MODIFICATION REQUEST:

Child Care Centre Modification

MP 09_0162 MOD 4 (Concept Plan)

MP 10_0177 MOD 13 (Project Application)

Figure 3: Proposed Concept Plan land use plan illustrating the enlarged childcare centre location
(Source: Proponent's EA)

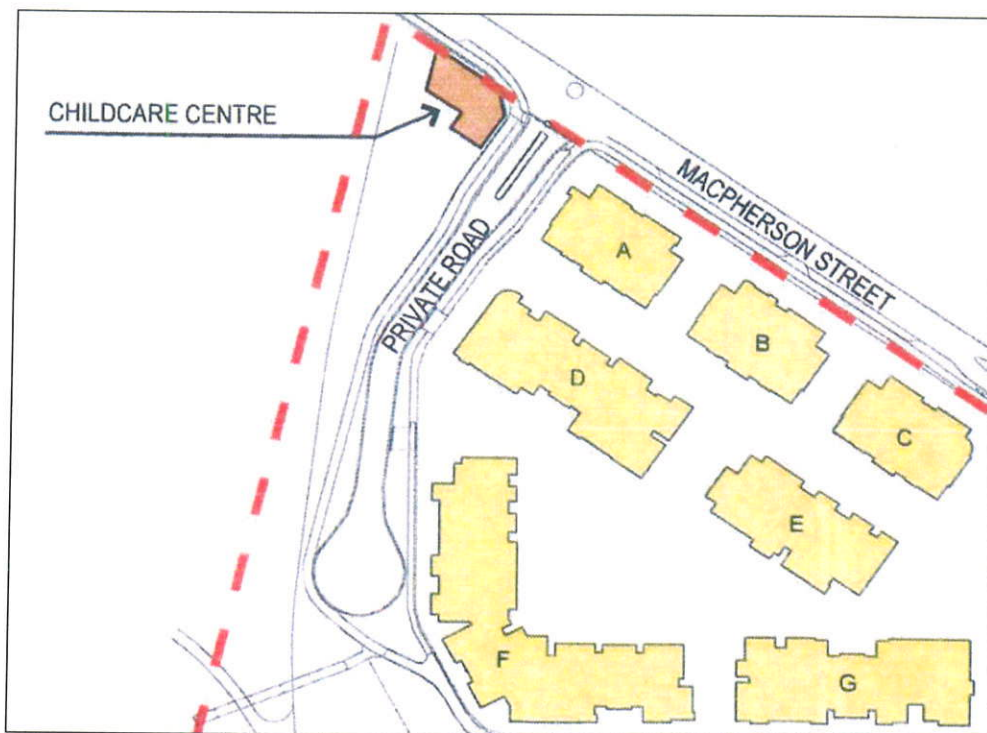
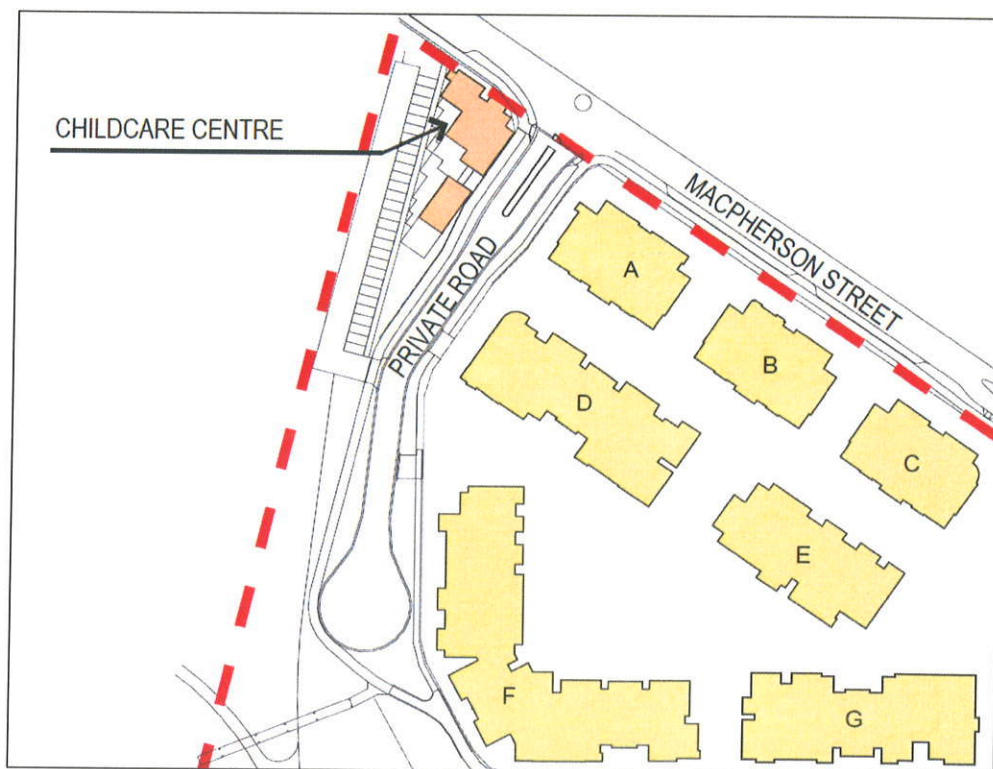
- an enlarged childcare centre through the provision of an additional storey (previous floor area of 270m², proposed 694.5m²);
- an enlarged car parking area (catering for 25 car parking spaces) located over an area to be dedicated to Council (**Figures 2 and 3** provide a comparison between the approved and proposed Concept Plan layout relating to the location of the childcare centre); and
- retention of existing dedication of land to Pittwater Council.

Figure 4: Proposed childcare centre and associated parking area (Source: Proponent's additional information)

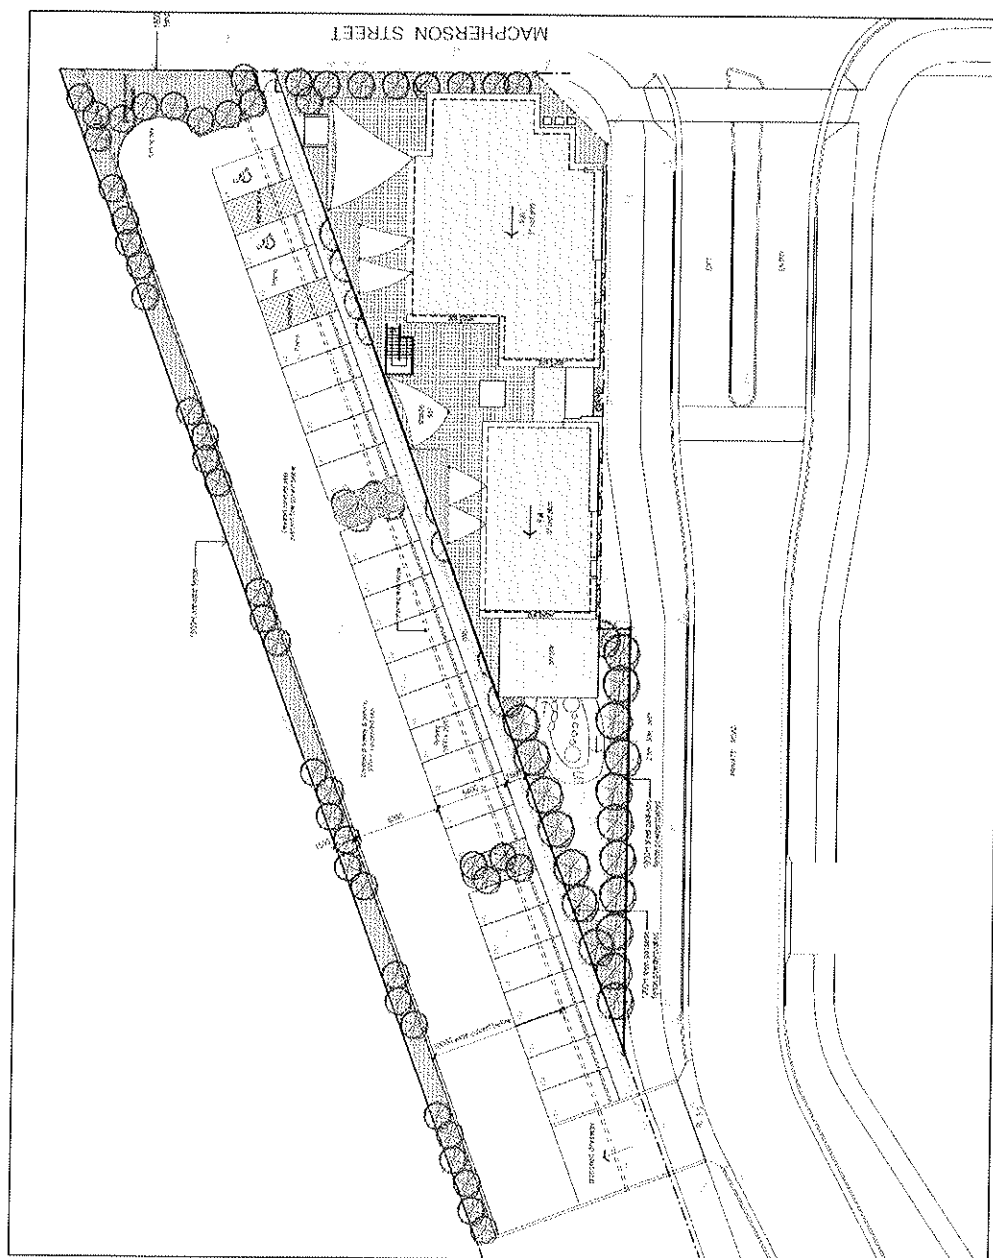
Vehicular access to the childcare centre is provided via an internal road accessed off Macpherson Street, through a dedicated car park entrance approximately 70 metres from Macpherson Street intersection (refer to **Figure 4** above). This access point is located on the opposite side of two driveways serving the existing residential development constructed to the east of the childcare centre on the proponent's site.

Council raised concerns with the proposed aisle width (6.395 metres) not being provided in accordance with AS2890 where parking space widths of 2.6 metres are to be provided. Council recommended that the aisle width be increased to 6.6 metres or alternatively an aisle width of 6.2 metres would be acceptable if 11 parking spaces assigned for the drop-off / collection of children be increased from 2.6 metres to 2.7 metres.

Council also raised concerns with the design of the car park and recommended the deletion of the closest car parking space to the proposed driveway to improve safety and eliminate conflicts. Given the proposed car parking provision is in-excess of RMS requirements (refer below), the department supports deletion of this space to provide for a more generous vehicular manoeuvring space into and out of the car park.

The department notes that a recommended increase in parking space width to 2.7 metres can be achieved with a reduction to the width of the two landscaped areas, combined with the removal of the car parking space that adjoins the proposed driveway. A suitable condition is recommended to address this issue.

The submitted car parking plan indicates the provision of 25 spaces, which is 2 spaces greater than the RMS requirement. As discussed above, the department recommends the deletion of 1 space to provide an improved car park entry and exit arrangement, which reduces the number of spaces to 24.

Figure 5: Extract of Stage 1 Project approved plan (Macpherson Street located on the right hand edge of the childcare facility and the overland flow path location added for context (green))

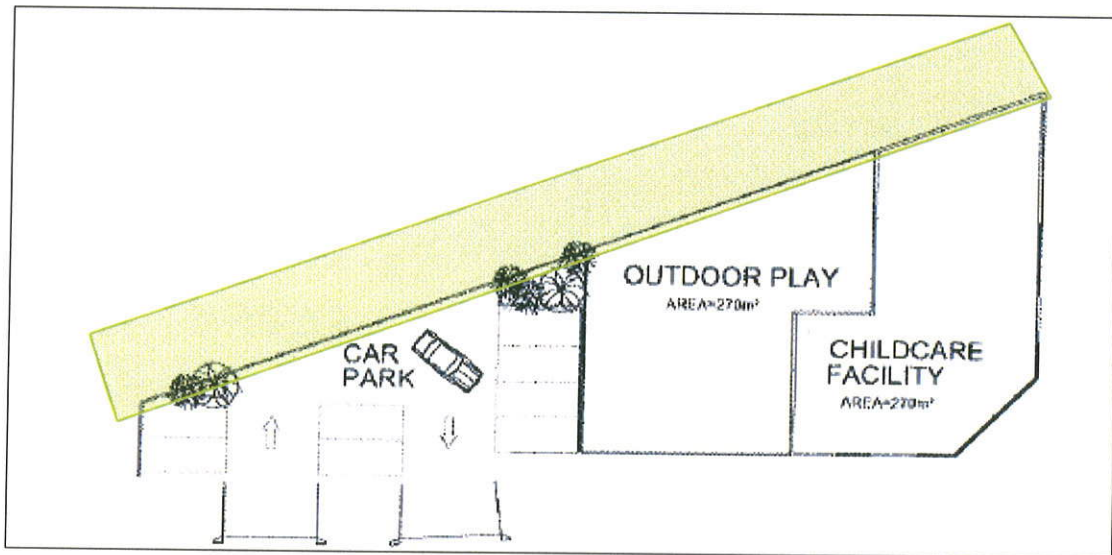
Council raised concern regarding the built form of the modified proposal and its impact on the streetscape. In particular, Council raised concern that:

- the two storey built form of the building and the car parking area would impact upon the streetscape and the residential amenity of the adjoining properties; and
- the nil setback to the Macpherson Street boundary (as originally exhibited) provides no opportunity for landscaping to soften the bulk of the building, unlike the residential buildings on the site and as provided for along Macpherson Street.

However, following concerns raised by Council and the department regarding the compatibility of the nil setback (having regard to the prevailing 6.5 metre setback of the adjacent 3-4 storey development), the proponent revised the design to provide a 2 metre setback to Macpherson Street to allow for landscaping to soften the appearance of the building and the car parking area.

Noting the above, the department considers that the proposed 2 metre setback addresses Council's earlier concerns in that it now provides for an opportunity for landscaping to soften the bulk of the building and the associated car parking area. Also, the department is of the view that despite the building including a 2 metre setback to Macpherson Street that does not match the 6.5 metres setback of the adjacent development, this is acceptable as it allows for outdoor play areas away from the street front.

Figure 8: Proposed car parking area to be constructed over overland flow path (Source: Proponent's additional information)

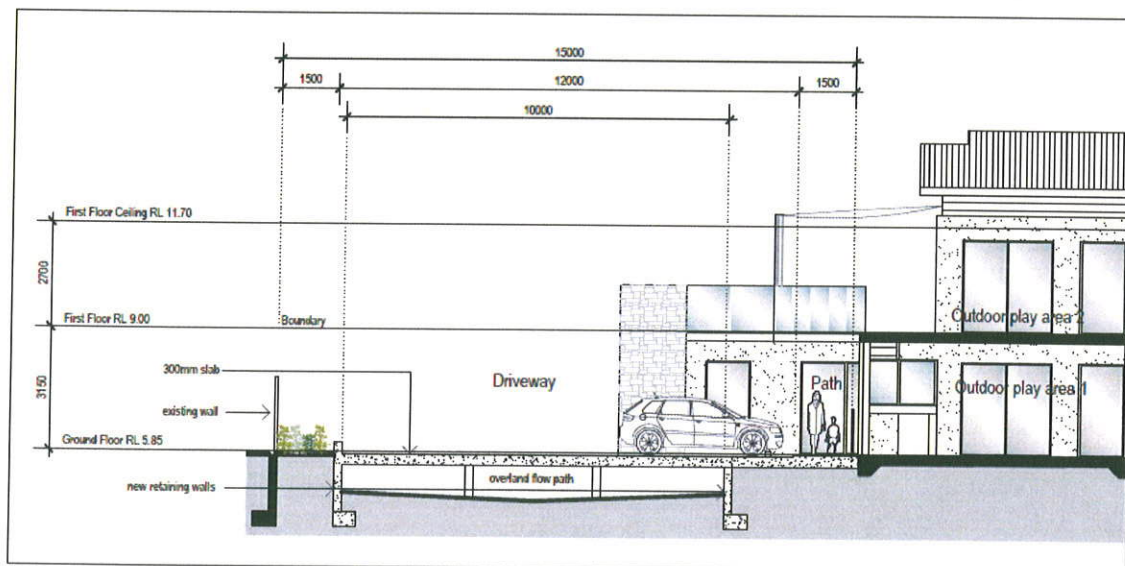
The proponent seeks to construct a car parking area servicing the childcare centre over an area designated as an overland flow path to within 1.5 metres of the western property boundary (**Figure 7**). The design of the car parking area incorporates a raised platform over the overland

flow path, providing a clearance of approximately 600mm from the bottom of the car parking platform and the top of the car parking area at a level of RL 5.80 (**Figure 8**).

Council raised concerns with the proposal to construct a car parking area over the overland flow path and questioned whether the proposed works would redirect overland flows onto surrounding properties. Additional justification was also requested to ensure that the proposed design does not impact upon the flood modelling, which considered impacts of the flood events up to the Probable Maximum Flood (PMF).

Having regard to these points, the department considers the proposed design to be acceptable and recommends that the final design of the car parking structure, to be prepared by a suitably qualified engineer, include consideration of the design and appropriate measures to ensure that the overland flow path is maintained and free of obstruction. The condition also requires details being provided to the Private Certifying Authority demonstrating consultation with Pittwater Council has occurred during this design process.

- a) *Engineering plans and specifications for the car parking area located over the overland flow path are to be endorsed by a suitably qualified engineer prior the issue of the relevant Construction Certificate. Details are to include the design and measures proposed to ensure that the overland flow path is maintained and free of obstruction (by the developer or operator of the centre) and how access is to be provided should access be required. Documentation is to be provided to the satisfaction of the PCA demonstrating consultation with Pittwater Council.*
- b) *An easement is to be created relating to the area beneath the car parking area to be maintained (by the developer or operator of the centre) for the purpose of an overland flow path to the satisfaction of Pittwater Council.*
